**CALIFORNIA COASTAL COMMISSION**

**STAFF REPORT:**  
**PERMIT AMENDMENT**

APPLICATION NO.: **1-06-022-A1**

PROJECT LOCATION: Ten Mile River Bridge, Highway 1, ten miles north of Fort Bragg, Mendocino County

42" HIGH ST-10 BICYCLE RAIL  
DECORATIVE ARCH OPTION

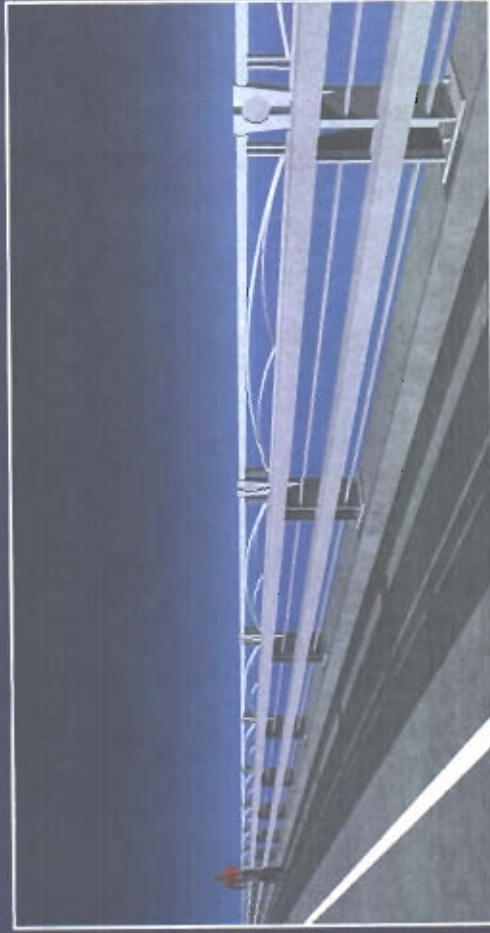
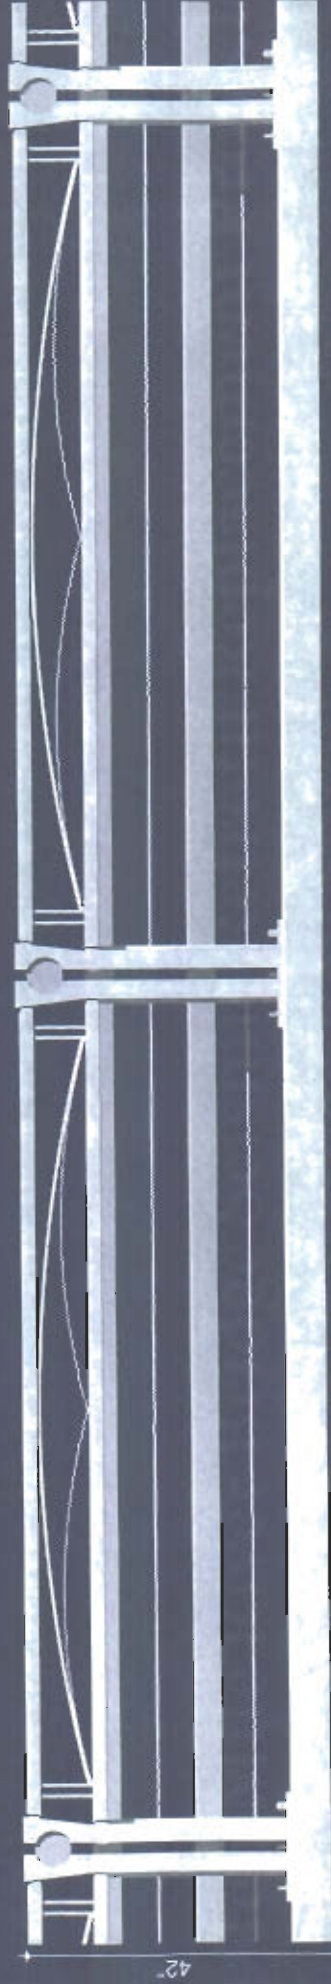
AMENDMENT REQUEST: Install bridge railings designed to minimize visual impacts as required by Special Condition No. 18 of the original permit including the use of a 42-inch-high pedestrian rail on the west side of the bridge, a metal guard rail (ST-10) separating pedestrians from the southbound traffic lane, and a 42-inch-high multi-purpose guard rail/bicycle rail on the east side of the bridge.

The resulting design incorporates a 42-inch-high pedestrian rail on the west side of the bridge, a metal guard rail (ST-10) separating pedestrians from the southbound traffic lane; and a 42-inch-high multi-purpose guard rail/bicycle rail on the east side of the bridge. The pedestrian and multi-purpose rails both employ a decorative arch motif that emphasizes the haunch (arch) of the superstructure. In addition, the rail design incorporates a decorative "button" detail, at the top of the vertical posts, which echoes the button detail on the superstructure. Though the two rails are not identical, because the multi-purpose rail uses the crash-tested ST-10 as its base, the overall design is unified and complements the bridge design. The Commission's Road's Edge Subcommittee reviewed the design and has endorsed it.

42" HIGH BICYCLE & PEDESTRIAN RAIL  
DECORATIVE ARCH OPTION

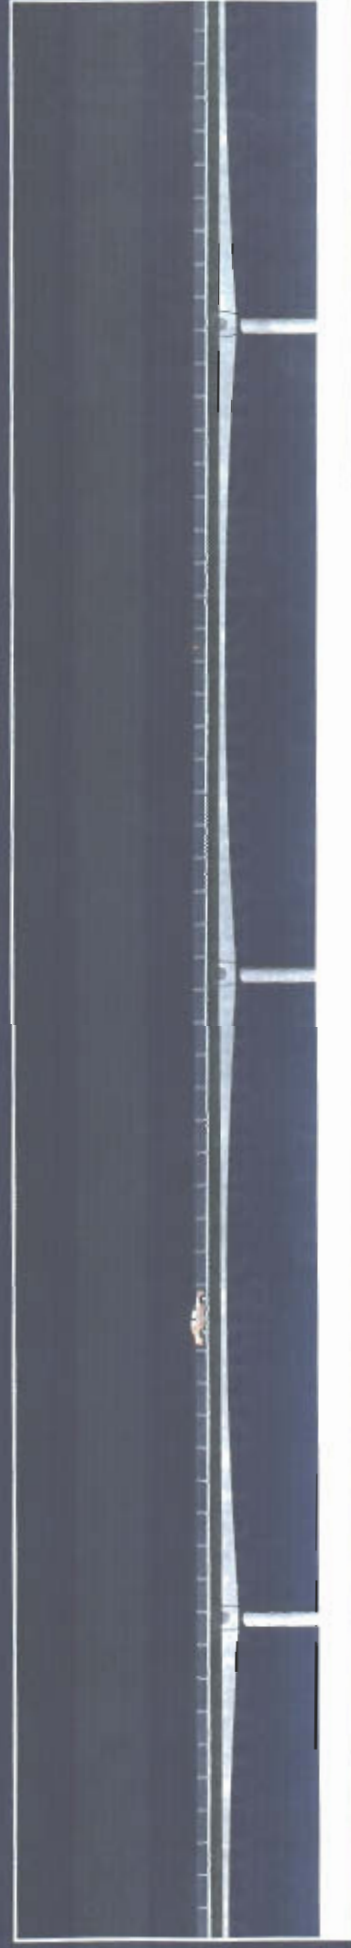
The final Design Plan incorporates a 42-inch-high pedestrian rail on the west side of the bridge, a metal guard rail (ST-10) separating pedestrians from the southbound traffic lane; and a 42-inch-high multi-purpose guard rail/bicycle rail on the east side of the bridge. The pedestrian and multi-purpose rails both employ a decorative arch motif that emphasizes the haunch (arch) of the superstructure. In addition, the rail design incorporates a decorative "button" detail, at the top of the vertical posts, which echoes the button detail on the superstructure. Though the two rails are not identical, because the multi-purpose rail uses the crash-tested ST-10 as its base, the overall design is unified and complements the bridge design.
